Exhibit Summary

Dairy Facility: Faria Dairy, DP-923

EXHIBIT 3223-28

Tute Faria East Dairy Overall Site Layout

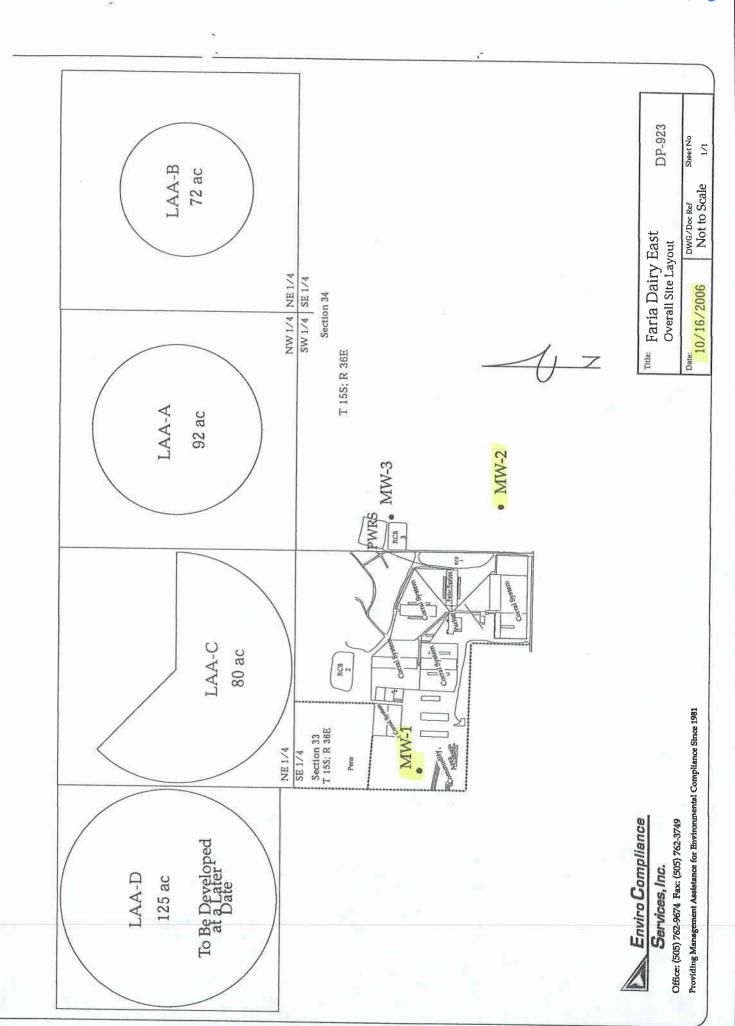
Description: Maps submitted by the permittee to the department indicate that two monitoring wells have been mislabeled such that a well intended to be hydrologically downgradient of a contamination source was switched with one that is intended to be hydrologically upgradient of the facility.

On the maps dated 11/12/2004 and 10/16/2006, monitoring well MW-2 is intended to be located hydrologically downgradient of a stormwater impoundment and monitoring well MW-1 is intended to be located hydrologically upgradient of the facility. The map dated 10/08/2008 has the wells reversed such that MW-1 is intended to be located hydrologically downgradient of a stormwater impoundment and MW-2 is intended to be located hydrologically upgradient of the facility.

Submitted ~ 2003

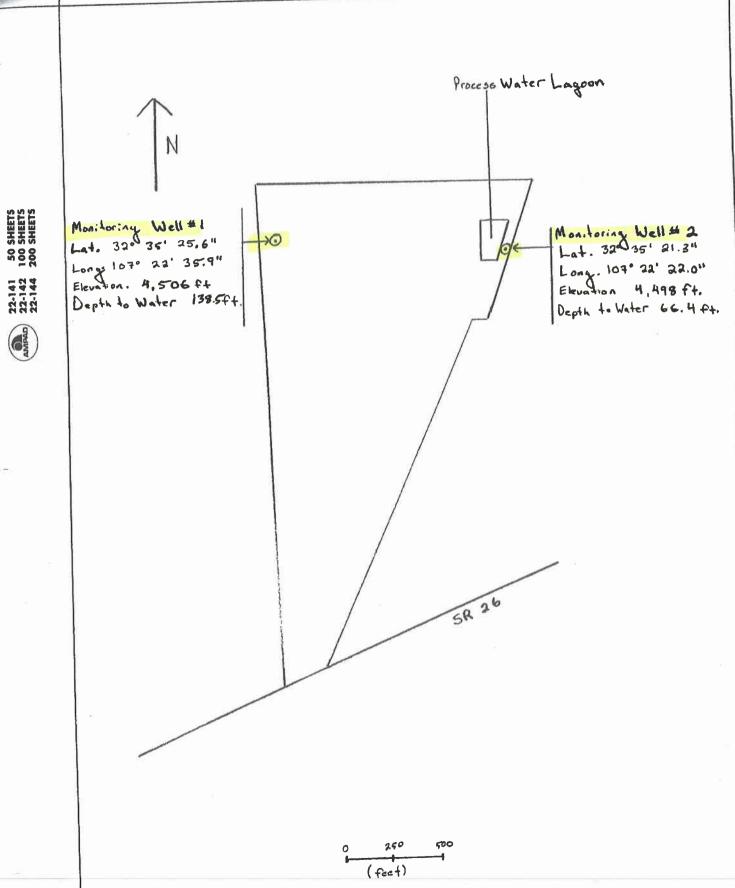
Description: Maps submitted by the permittee to the department indicate that two monitoring wells have been mislabeled such that a well intended to be hydrologically <u>downgradient</u> of a contamination source was switched with one that is intended to be hydrologically <u>upgradient</u> of the facility.

On the map submitted in 2003, monitoring well MW-2 is intended to be located hydrologically downgradient of the wastewater impoundment and monitoring well MW-1 is intended to be located hydrologically upgradient of the facility. The maps submitted in 2005 and 2009 have the wells reversed such that MW-1 is intended to be located hydrologically downgradient of the wastewater impoundment and MW-2 is intended to be located hydrologically upgradient of the facility.
